Oxford University Development

Begbroke Innovation District

Environmental Statement
Addendum

November 2023

Figure 4 – Primary 2 - No mitigation

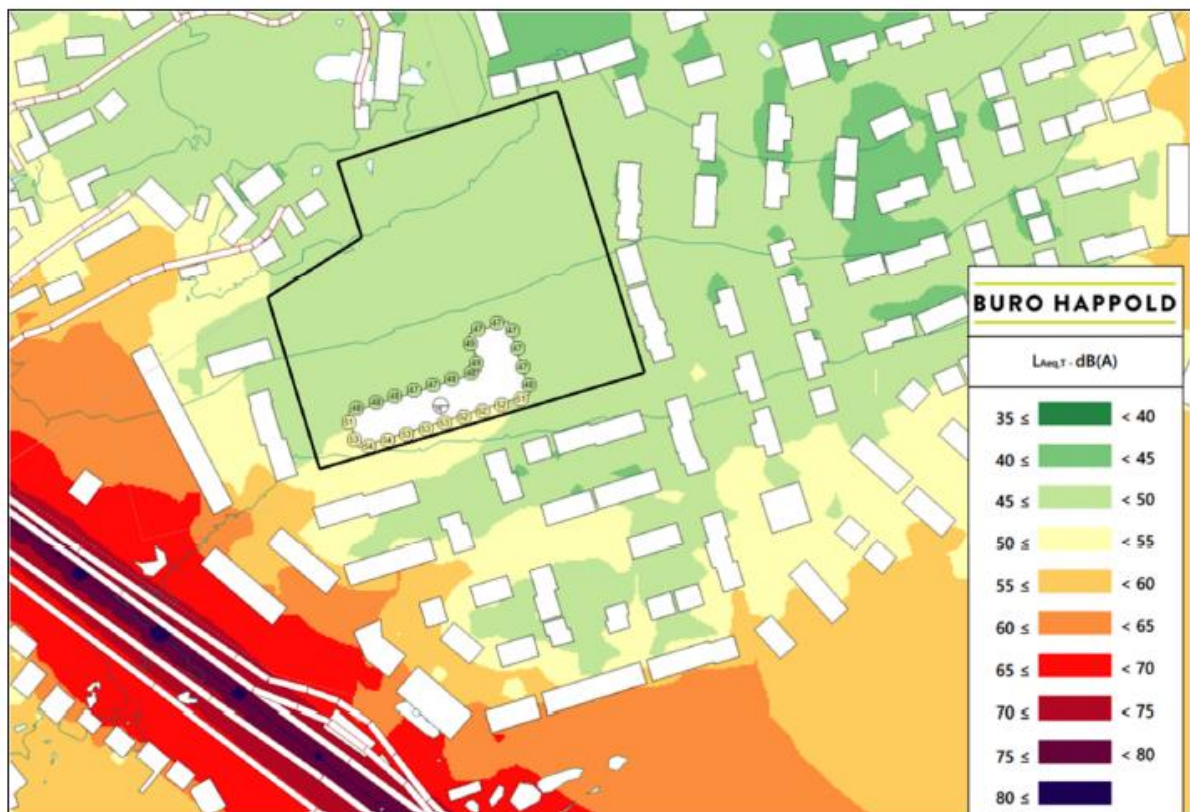
A revised location for Primary School 2 in the south of the Site to a proposed location approximately 100m further east, away from the A44. Residential land uses are introduced between the revised location of Primary School 2 and the A44 (in place of the former Primary School 2 location).

Figure 4 shows the indicative noise contours for the 16 hour day in proximity to Primary School 2 (in its revised location), with the dominant noise source being the A44. It is noted that without mitigation, most of the external areas of the school would experience noise levels which do not exceed 50 dB $L_{Aeq,T}$, with the exception of the south west corner of the school boundary where the predicted levels just exceed the 50 dB criterion set by OCC. Therefore, the school playing fields would comply with the outdoor levels recommended in the OCC guidance without additional mitigation. From an acoustic perspective the school could be naturally ventilated.

Mitigation – either in the form of acoustic boundary treatment to the school site or along the A44 (as stated within the Development Specification) would achieve the small reduction required for the whole boundary to comply with the condition, if it was considered necessary to do so (given the exceedance of the criterion is restricted to such a small area. It is considered that in the revised

location, the levels in external spaces at the school would be within the Acoustics of Schools Design Guide recommendations for external play areas and generally comply with OCC's criteria. and thus would provide a suitable external environment.
